Bulletin No: Seatback09
Release Date: 5/01/2009
Effective Date: 5/01/2009
Supersedes: N/A
Completion Date: 5/01/2009
Page: 1 of 1

SAFETY ALERT

Ride Manufacturer: J&J Amusements, Inc	Affected production dates: All
Ride Name: J&J Go Karts	Affected Serial Numbers: All
Model Number: All accept Viper, Scorpion & Sidewinder	
Abstract Of Issue: Under severe impact the steel seat back portion of the go-kart frame can become bent forward. This can cause an excess gap between the seat and the roll bar.	
Reason For Release: This gap can constitute a hazard	
Action To Be Taken: If the steel seat back has been damaged contact J&J parts department for an update parts kit. This kit will be provided and shipped to you free of charge. Please advise how many kits (1 per go-kart) are needed. Seatback Reinforcement kit (#1-99-A0003)

Detail of Issue:

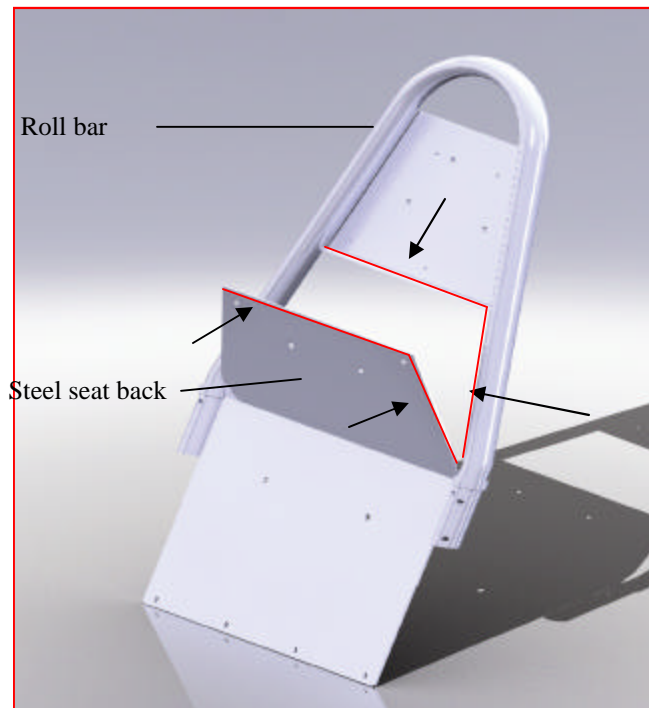
This illustration shows an extreme gap between the seat back and roll bar and would be a hazard.
